PRESSURE/TEMPERATURE OPERATING CURVES AND ASSESSMENT  
OF RT<sub>PTS</sub> CONCERNS FOR KEWAUNEE NUCLEAR PLANT

Final Report

Description, Safety Evaluation, and Significant Hazards Determination

Proposed Amendment No. 71 to the KNPP Technical Specifications

TS 3.1, Figures TS 3.1-1 and TS 3.1-2

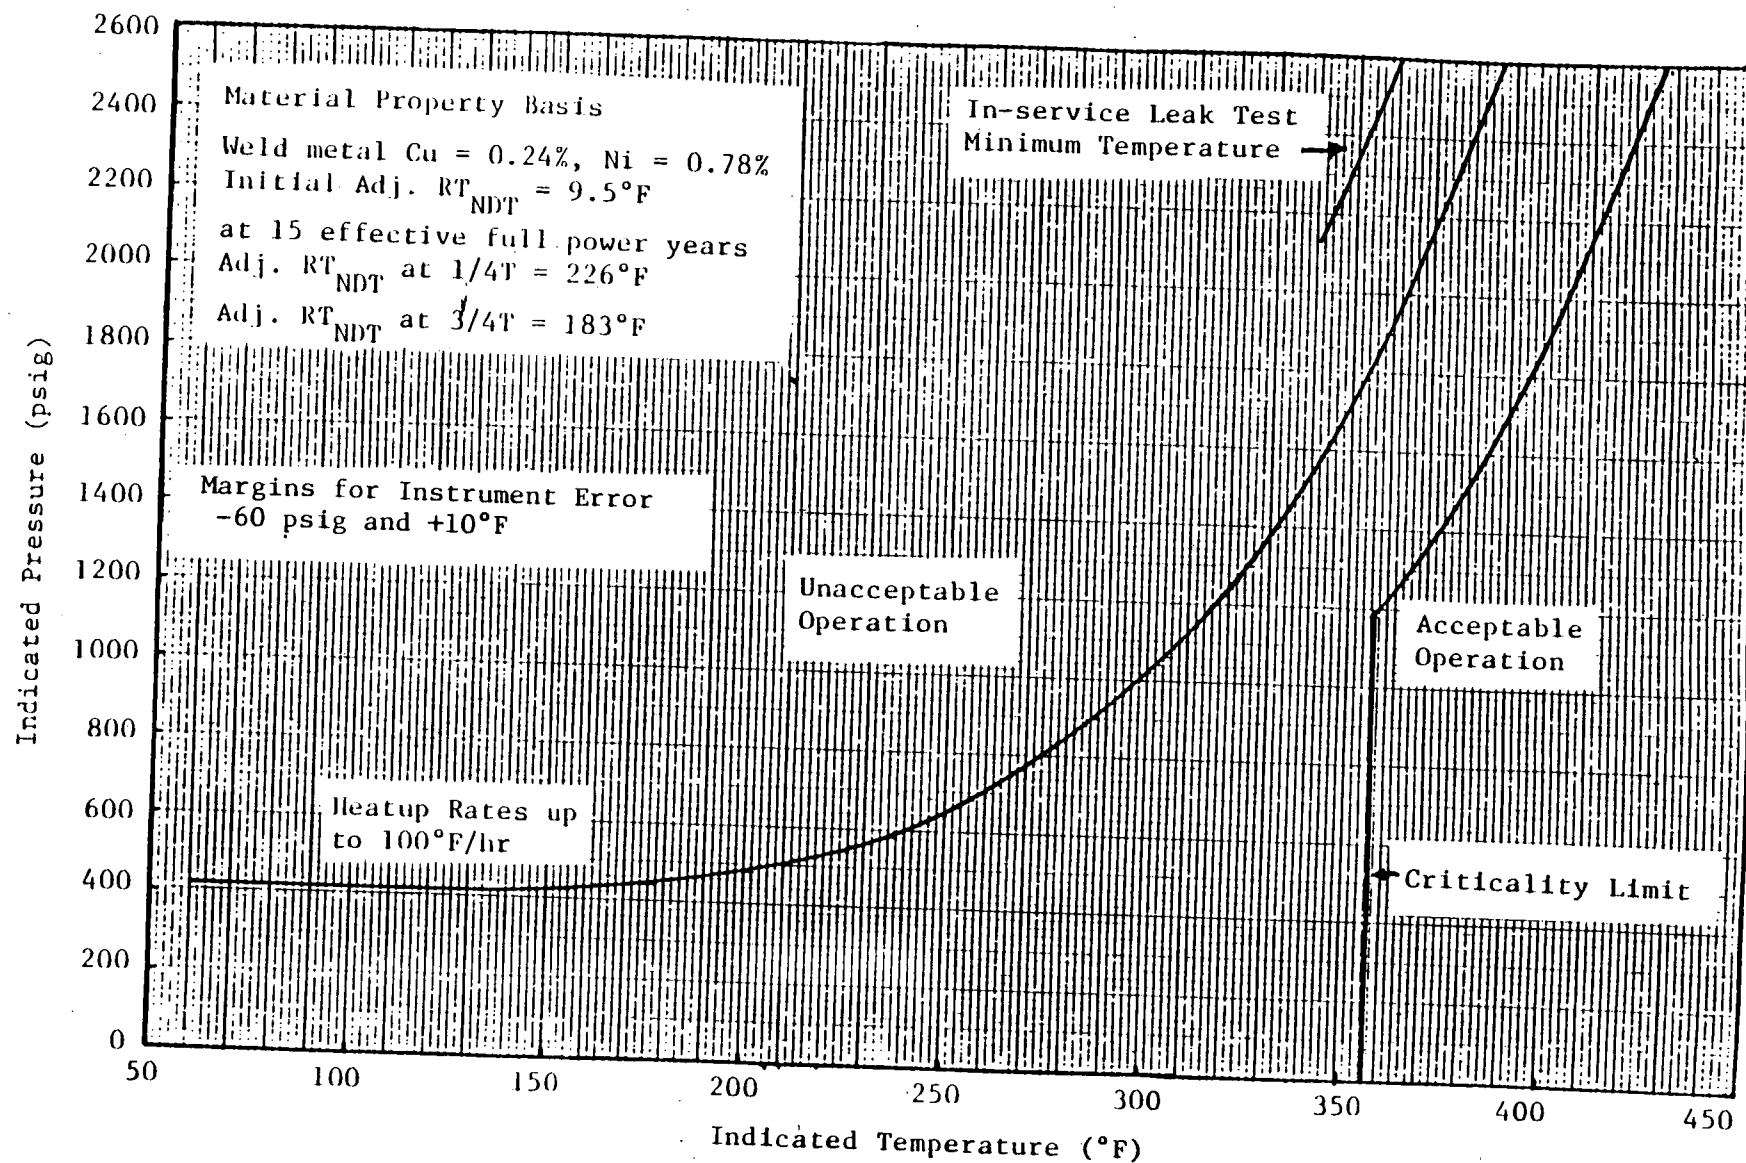
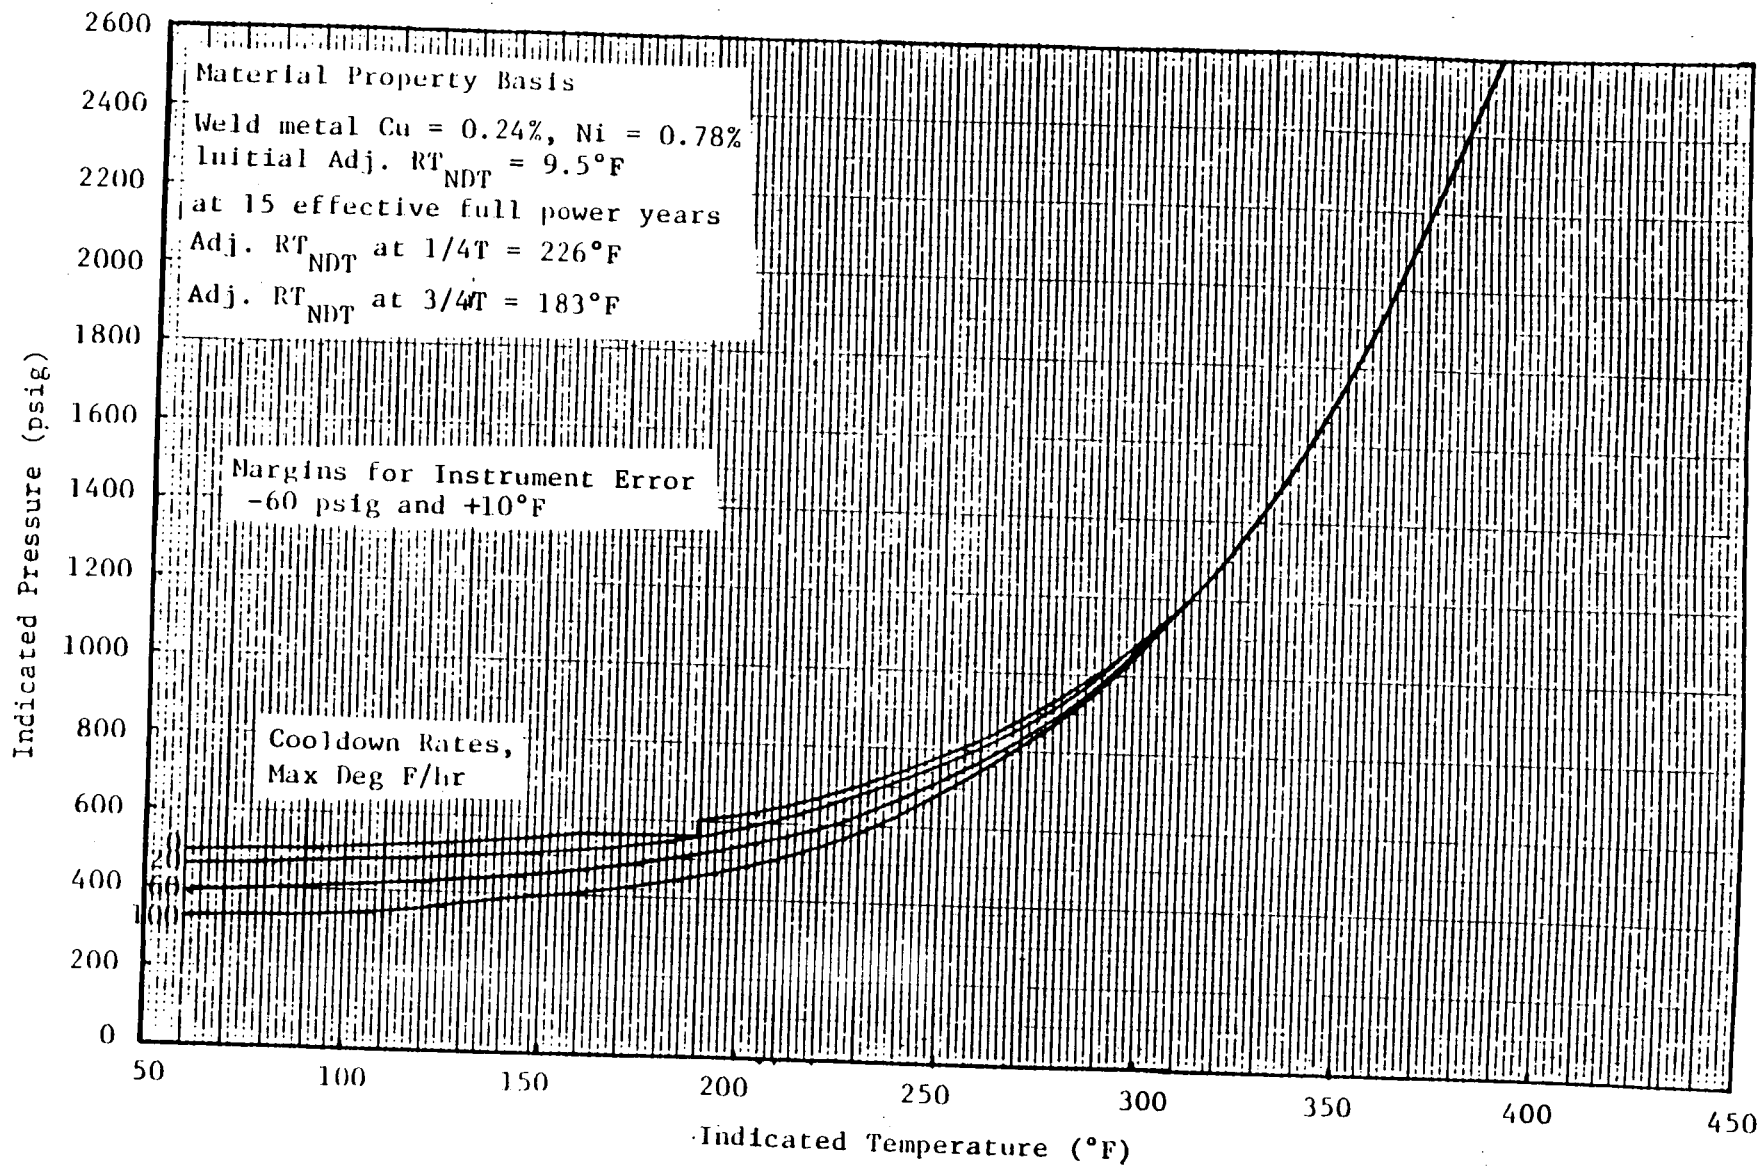
The previous heatup and cooldown limit curves have been replaced with revised limit curves which are valid to 15 EFPY. These curves have been prepared in a manner consistent with NRC Regulatory Standard Review Plan Section 5.3.2, "Pressure-Temperature Limits," Draft Regulatory Guide 1.99, Revision 2, and ASME Boiler and Pressure Vessel Code Section III, Appendix G, 1983 edition through Summer, 1984 addenda. The major differences in the preparation of the revised limit curves compared to the previous curves are:

- 1) The assumption of higher copper and nickel contents for the limiting reactor vessel weld. The basis for the new assumptions is described in Attachment A to this letter.
- 2) The use of Draft Revision 2 of Regulatory Guide 1.99 instead of Revision 1. Revision 2 is a technical improvement over the methodology of Revision 1.
